Regulation No. 13-H (Passenger Car Braking)

Proposal for introducing requirements for Brake Assist Systems into Regulation 13H.

The text reproduced below was prepared by the expert from the European Commission with the aim of introducing requirements for Brake Assist Systems (where mandated by Contracting Parties) into Regulation 13H. The text is based on Supplement 7 of Regulation 13H (as adopted at the 146th session of WP29) and document GRRF/2008/15 as amended at the 64th session of GRRF.

Figure 1a: Pedal force characteristic needed in order to achieve maximum deceleration with category "A" BAS

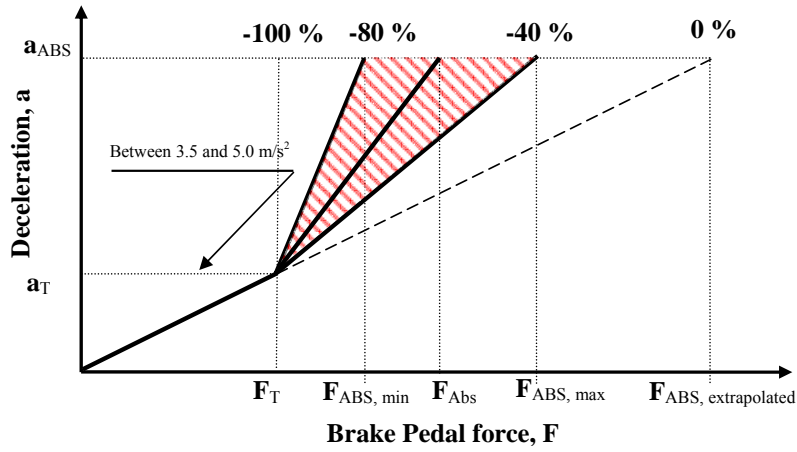
- 3.2.4. A straight line is drawn from the origin through the point F_T, a_T (as shown in Figure 1a). The value of brake pedal force "F", at the point of intersection between this line and a horizontal line defined by $a=a_{ABS}$, is defined as $F_{ABS, extrapolated}$:

Figure 1b: Pedal force characteristic needed in order to achieve maximum deceleration with category "A" BAS

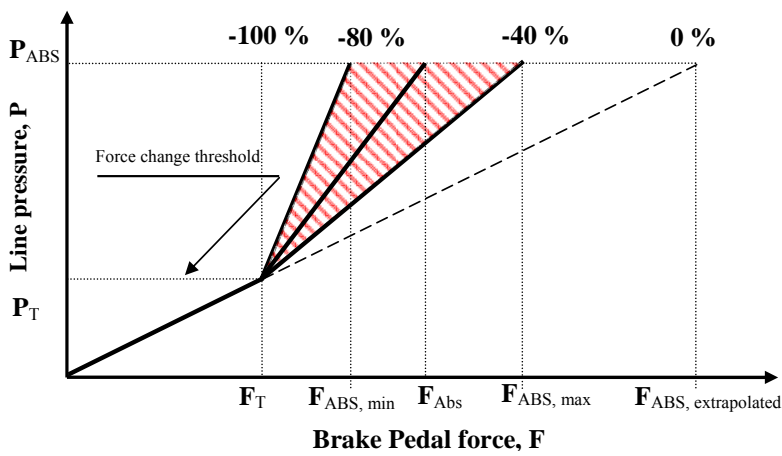
- 3.2.5.2. The threshold pressure P_T shall be stated by the manufacturer and correspond to a deceleration in the range of 2.5 - 4.5 m/s².
- 3.2.5.3. Figure 1b shall be constructed in the manner set out in paragraph 3.2.4., but using line pressure measurements to define the parameters set out in paragraph 3.2.5. above where:

Figure 2: Example of test 2 of a category "B" BAS system

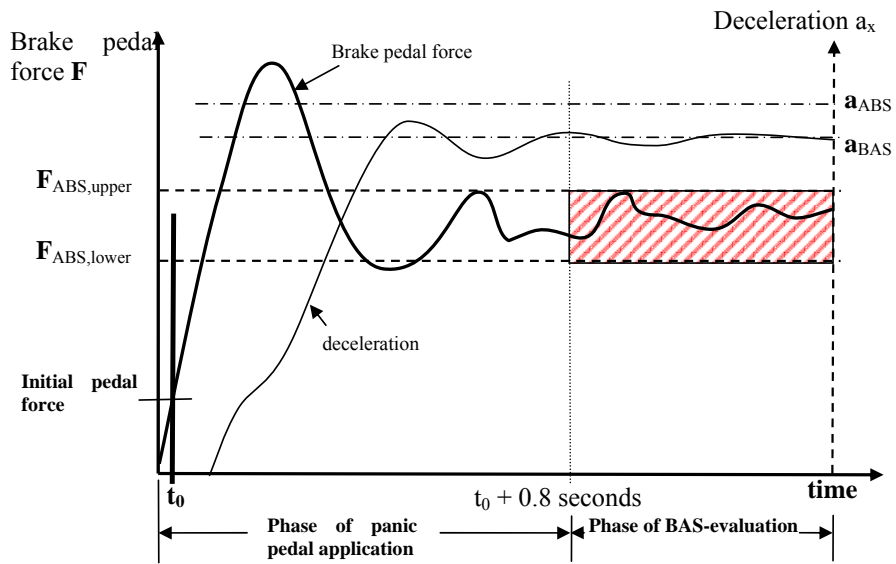
The vehicle shall be driven in a straight line at the test speed specified in paragraph 2.4. above. The driver shall apply the brake pedal quickly according to Figure 2, simulating emergency braking so that BAS is activated and ABS is fully cycling.

After $t = t_0 + 0.8$ s and until the vehicle has slowed down to a speed of 15 km/h, the brake pedal force shall be maintained in a corridor between $F_{\text{ABS, upper}}$ and $F_{\text{ABS, lower}}$, where $F_{\text{ABS, upper}}$ is $0.7 F_{\text{ABS}}$ and $F_{\text{ABS, lower}}$ is $0.5 F_{\text{ABS}}$.

The presence of BAS 'B' is **demonstrated** if a mean deceleration (a_{BAS}) of at least $0.85 \cdot a_{\text{ABS}}$ is maintained from the time when $t = t_0 + 0.8$ s to the time when the vehicle speed has been reduced to 15 km/h.

Figure 3: Deceleration corridor for determination of F_{ABS} and a_{ABS}

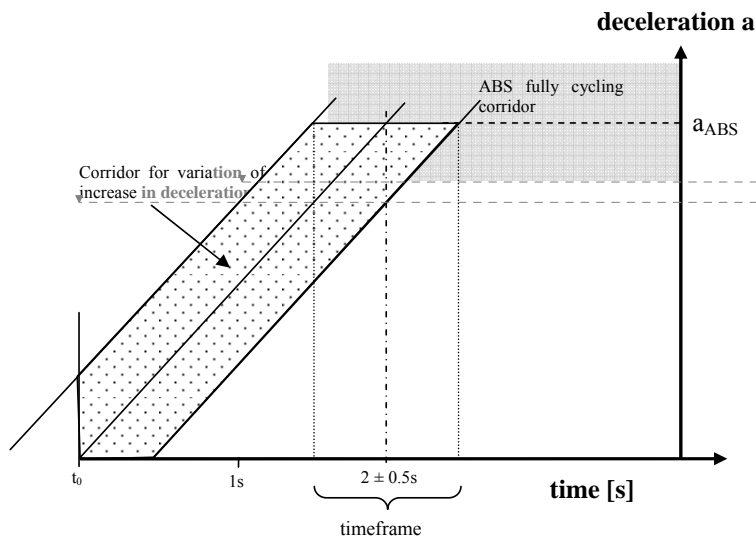
- 1.2. The brake pedal shall be applied slowly (without activating the BAS in the case of category B or category C systems) providing a constant increase of deceleration until ABS is fully cycling (Figure 3).

- 1.3. The full deceleration must be reached within the timeframe of 2.0 ± 0.5 s. The deceleration curve, recorded against time, must be within a corridor of ± 0.5 s around the centre line of the deceleration curve corridor. The example in Figure 3 has its origin at the time t_0 crossing the a_{ABS} line at 2 seconds. Once full deceleration has been achieved the pedal travel S_p shall not be decreased for at least 1 s. The time of full activation of the ABS system is defined as the time when pedal force F_{ABS} is achieved. The measurement shall be within the corridor for variation of increase in deceleration (see Figure 3).
